Calvert Cliffs Nuclear Power Plant
Independent Spent Fuel Storage Installation, License No. SNM-2505
NRC Docket No. 72-8

Subject: Amendment Request No. 1 to Renewed Materials License No. SNM-2505 for Calvert Cliffs Specific Independent Spent Fuel Storage Installation - Second Request for Additional Information, Part 2

SECOND REQUEST FOR ADDITIONAL INFORMATION, PART 2

Figure 1 – Distribution of Burnup for Discharged Fuel at Calvert Cliffs as of 6/30/2015 by Cladding Material

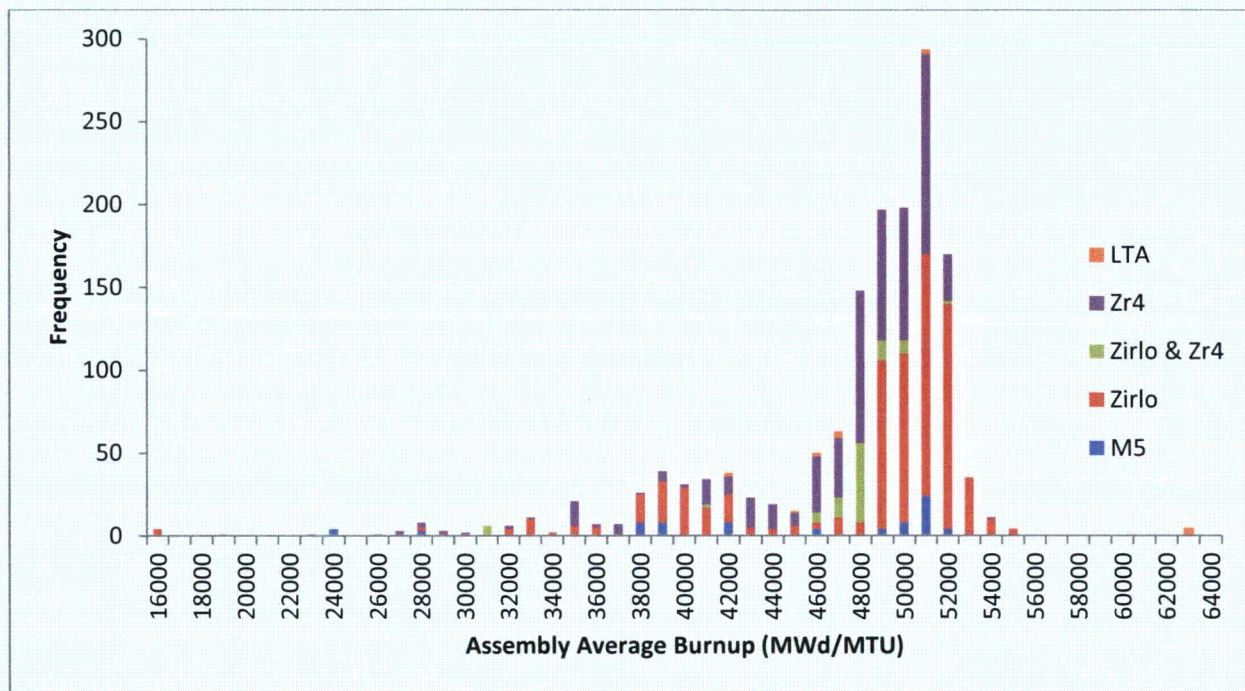
Provide details on how the data from the DOE-funded High Burnup Dry Storage Cask Research and Development Project" (HDRP) will be used to make a determination on safe storage of high burnup fuel up to 62 GWd/MTU.

The current maximum fuel assembly average burnup limit is 47,000 MWd/MTU for the NUHOMS® 24P DSCs and 52,000 MWd/MTU for the NUHOMS® 32P DSCs. The proposed amendment would add a new maximum fuel assembly average burnup limit of 62,000 MWd/MTU for fuel stored in NUHOMS® 32PHB DSCs. The High Burnup Fuel Aging Management Program in Attachment 4 of the supplement to the license renewal application (ML14267A065) was approved per guidance in ISG-24. ISG-24 indicates that the maximum burnup of the fuel in the application should be less than the burnup of the fuel in the demonstration. If the burnup is higher than the fuel in the demonstration program, the applicant would provide evidence, based on characteristics of the fuel, that the demonstration fuel is reasonably characteristic of the stored fuel and the additional burn-up would not change the results determined by the demonstration. Per the latest DOE Cask Demo Design Loading Plan (ML15133A082), the maximum burnups are: 55.5 GWd/MTU (ZIRLO™ cladding), 53.5 GWd/MTU (M5® cladding), 50.6 GWd/MTU (Zircaloy-4 cladding), and 50 GWd/MTU (low-Sn Zircaloy cladding). The applicant is asked to justify that the demonstration results from lower burnup cladding will be characteristic for higher burnup cladding; more specifically, that the acceptance criteria in the High Burnup Fuel Aging Management Program is adequate for burnups up to 62 GWd/MTU.

Figure 1 below provides the burnup distribution of fuel stored in the Calvert Cliffs spent fuel pool as of June 30, 2015. As can be seen, the majority of fuel with Zircaloy-4 or Zirlo cladding have assembly average burnups that are either bounded by, or only slightly exceed, that in the DOE Cask Demonstration Design Loading Plan. This occurs because the Westinghouse/Combustion Engineering (C-E) fuel rod design methods are only licensed for a peak fuel rod average burnup of 60 GWd/MTU for those cladding materials for C-E designed plants, as detailed in CENPD-404-P (see ML012670041), which effectively limits assembly average burnups to ~55-56 GWd/MTU. New batches of fuel with Zircaloy 4 or Zirlo cladding have not been loaded since 2010. AREVA fuel with M5 cladding has only been used at Calvert Cliffs since batches were loaded into the core in 2011. As a result, Figure 1 does not provide significant information on final discharge burnups for that cladding material. However, AREVA's fuel rod design method detailed in EMF-92-116PA (non-proprietary version can be found at ML003681063) is only licensed to a peak fuel rod average burnup of 62 GWd/MTU, which effectively limits assembly average burnup to < 58 GWd/MTU. Therefore, it is expected that the DOE Cask Demonstration results for M5 cladding will also be representative of the highest burnup AREVA fuel stored in the 32PHB DSCs at Calvert Cliffs. The few Lead Test Assemblies (LTAs) with very high burnup and/or alternative cladding materials or dimensions are not being targeted for storage in the 32PHB DSC at this time.
